**Development Permit Panel
Wednesday, August 9, 2023**

**1. DEVELOPMENT PERMIT 21-940028
(REDMS No. 7236092)**

Permit the construction of 35 townhouse units at 10140, 10160, 10180 No.1 Road and 4051 Cavendish Drive on a site zoned "Town Housing (ZT88) - No. 1 Road (Steveston)".

CONVERTIBLE UNIT LAYOUTS

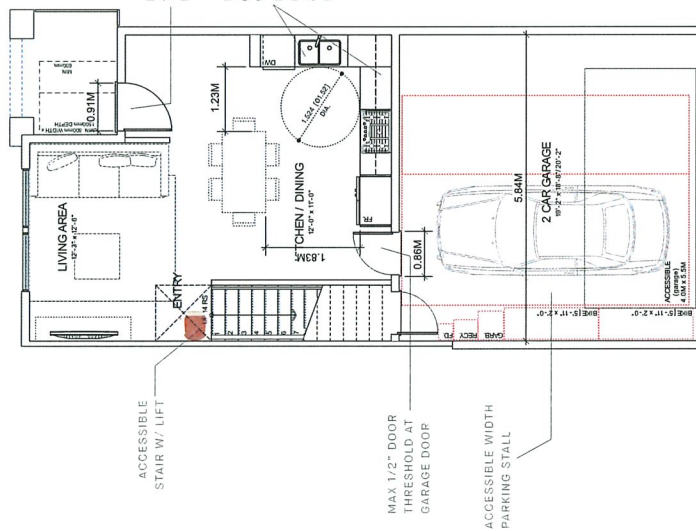
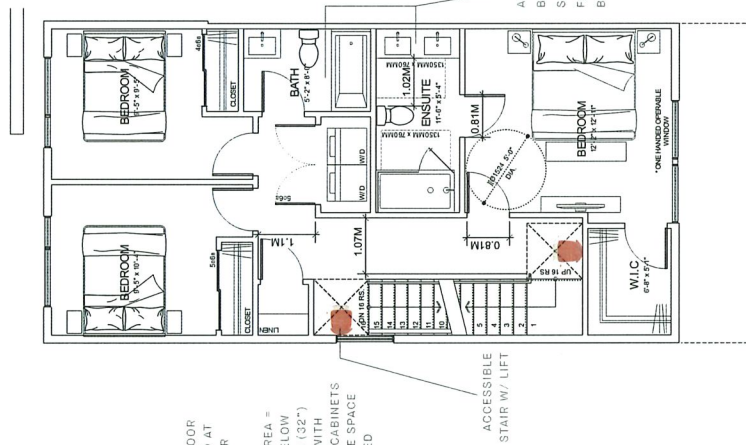
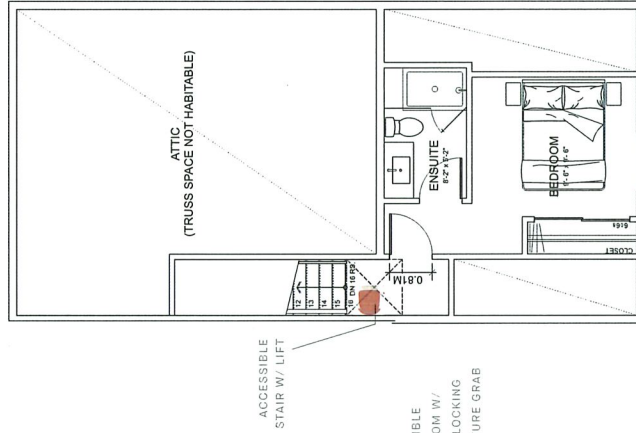
In reply to queries from the Panel, the applicant noted that (i) the attic on the third floor of convertible unit C1 will be within the single roof form of the building that will read like a two-and a half-storey building, (ii) the applicant could consider installing a pedestrian pathway to connect the secondary play area to the emergency vehicle access/pedestrian connector, (iii) no benches are proposed along the emergency access/pedestrian connector along Cavendish Drive, (iv) a detached utility building is provided adjacent to the central outdoor amenity area, (v) the sod boulevard with street trees along Cavendish Drive could be usable and provide play opportunities, (vi) the convertible units are accessible from the outside to their main entries, (vii) the Fire Department has been consulted regarding fire truck access into the site, (viii) the type of heat pumps proposed for the project has been proven to have no noise concerns, and (ix) the heat pumps are located on the ground floor and away from areas that are noise sensitive.
